**SUNDRY NOTICES AND REPORTS ON WELLS**  
**Do not use this form for proposals to drill or to re-enter an abandoned well. Use Form 3160-3 (APD) for such proposals.**

8. Well Name and No.  
Good Times P36A-2410 03H

Project: San Juan County, NM  
Site: S36-T24N-R10W (Good Times)  
Well: Good Times P36A-2410 03H  
Wellbore: STK  
Design: Plan #3

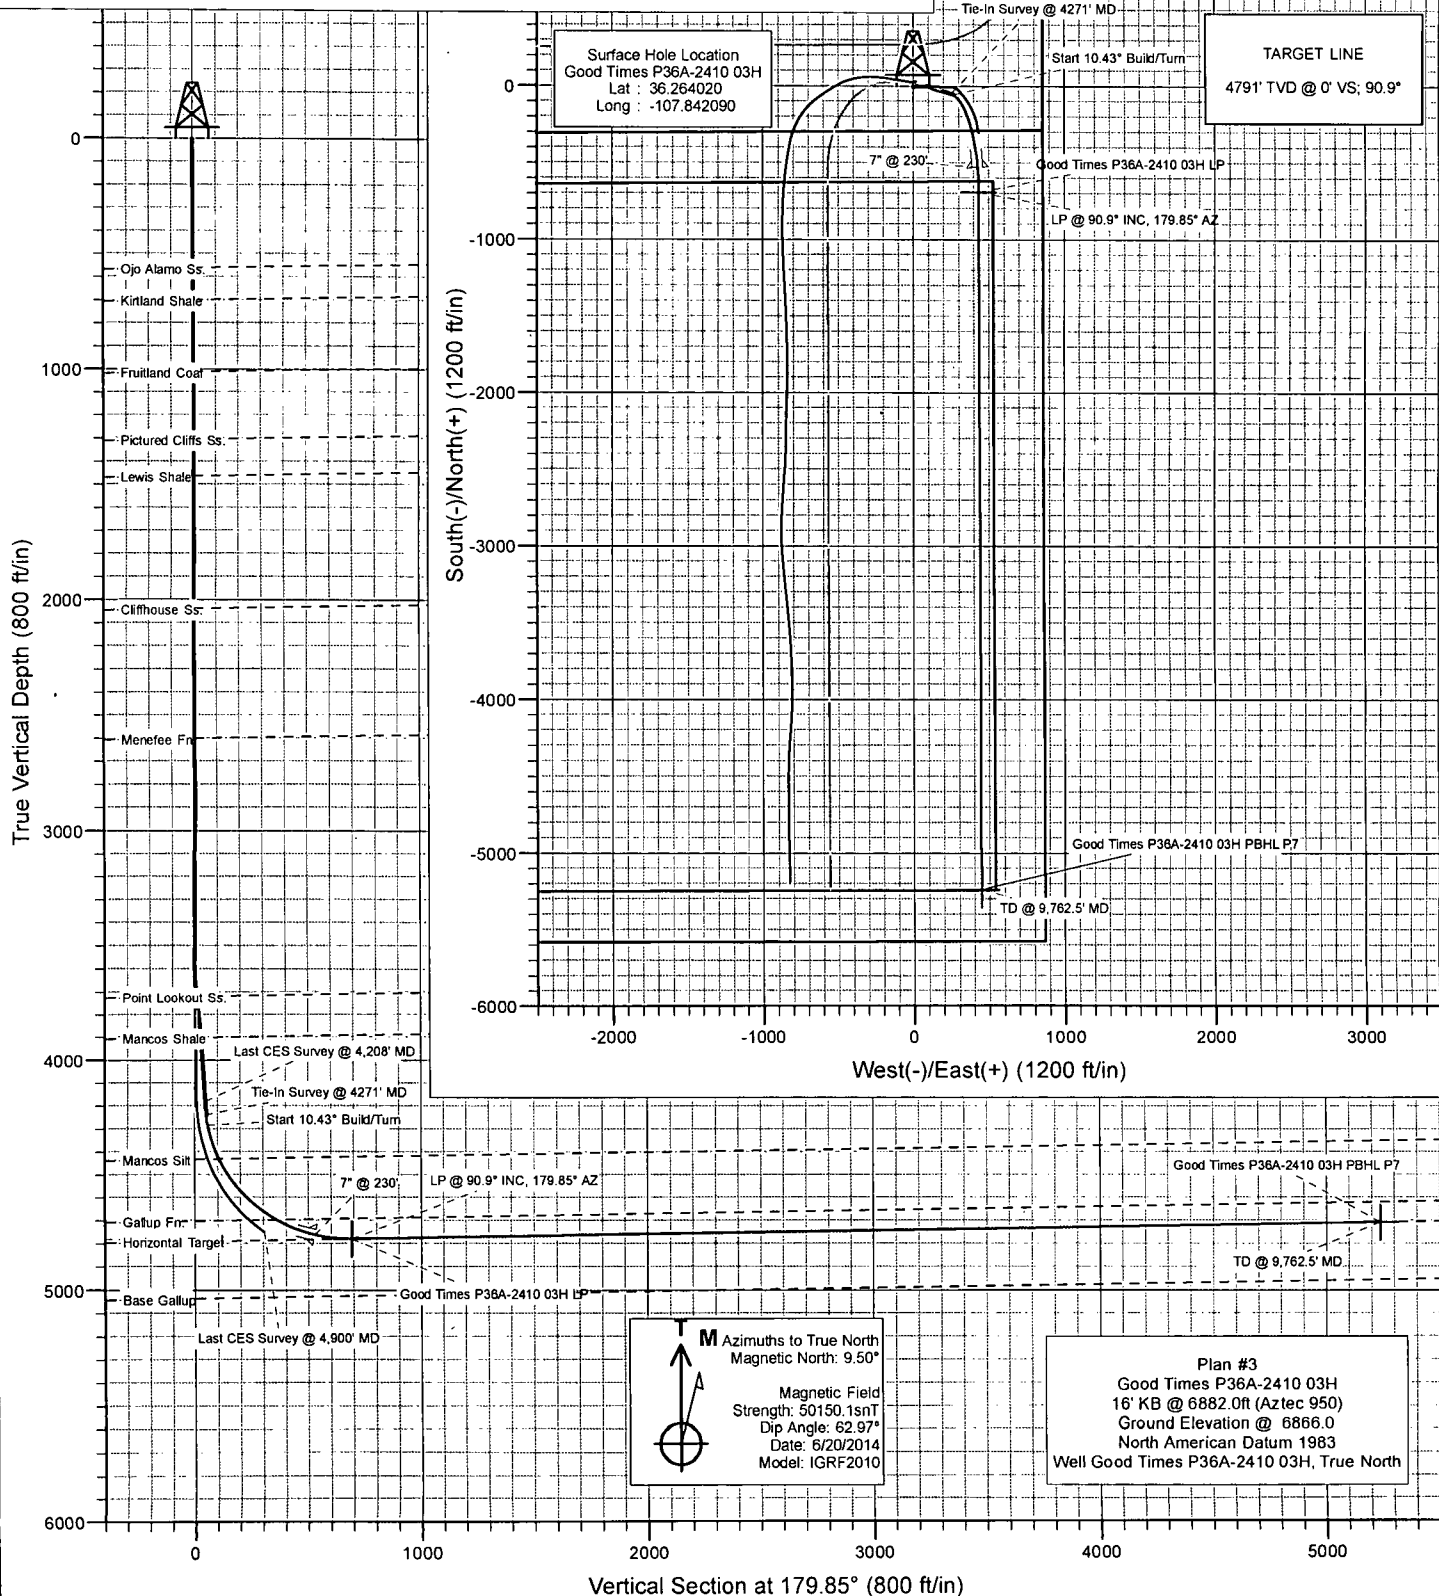
Encana Oil & Gas (USA) Inc. (Encana) would like to notify the BLM and OCD that adequate build rates were not able to be achieved during the initial attempt to drill the approved Good Times P36A-2410 03H wellbore. Sufficient build rates were still not achieved when the initial BHA was replaced with a higher bend motor. Therefore, Encana proceeded with the plug back and sidetrack procedure verbally approved by the BLM (6/21/2014) and in accordance with OCD requirements. A 600' cement plug was spotted from TD (4951') with a 200' spacer and a second 600' cement plug was spotted above the spacer. The two plugs isolate both the contact between the Gallup to the Mancos and the Mancos to the Point Lookout. Kick off of the plug was at 3657'. The sidetrack was successfully drilled to 7" ICP.

The 7" casing point and POE will both be similar to the permitted plan in relation to the section line and 330' setback. 7" is planned to be set at approximately 230' FNL. The last completion packer will be set on the legal side of the 300' setback. The BHL will remain the same as approved (330 FSL, 430 FEL Sec 1 T23N R10W).

Please find attached an updated Directional Drilling Plan, which reflects this change of plans.
